# 1968 Corvette: Service Bulletin: Choke and Hot Restart Problems

**Model and Year:** 1968 Corvette with 427 cu. in. Engine

**Bulletin No:** 68-T-23 Re-Issue

**Date:** Apr. 24, 1968

FIGURE 1

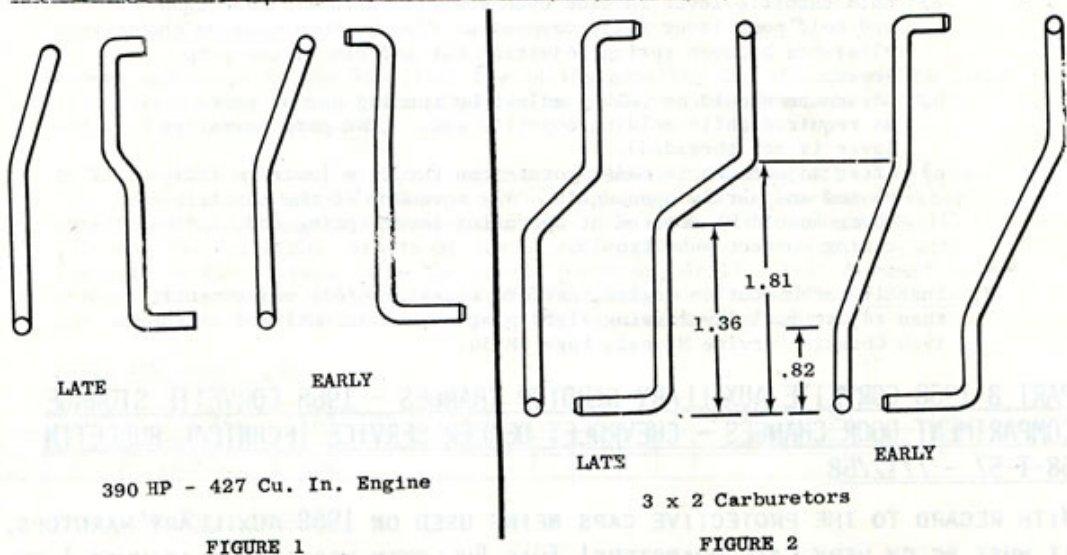
The hard cold starting problem may be due to interference or bind conditions of the choke rod, resulting in failure of the choke to move fully closed. Choke rod revisions corrected this possible condition with early October production vehicles. Field correction of this condition is outlined on Page2.

Install new choke rod (Part No. 3937738) which has a greater off-set and a reverse entry direction at the choke lever end. Adjust to one rod diameter interference by bending at the off-set as necessary.

FIGURE 3

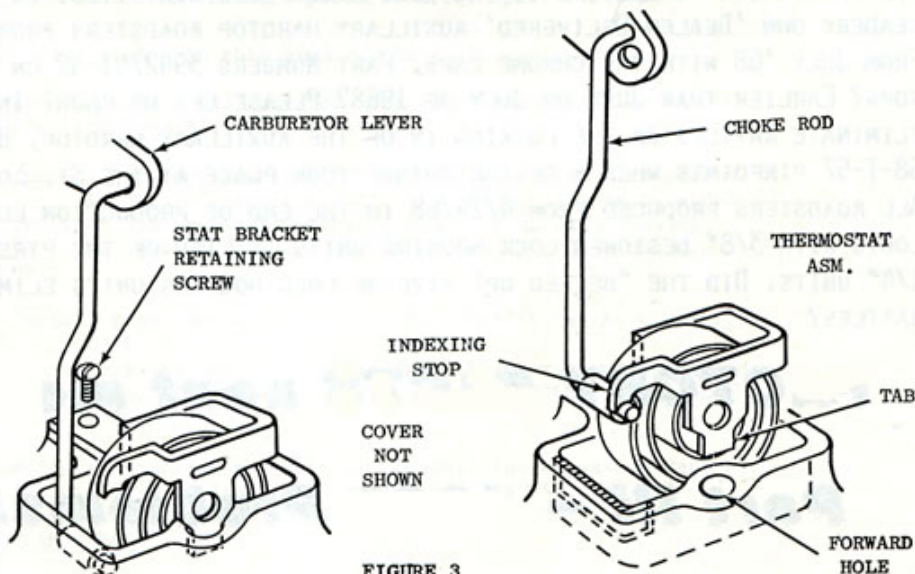
Install new choke rod (Part No. 3919899) which has a greater off-set leg length and check for interference between choke thermostat coil and the manifold pocket as shown in Figure 3. If interference exists in this area, adjust the coil as much as possible on its mounting location, and if necessary, grind the pocket area or the choke rod end to gain clearance needed.
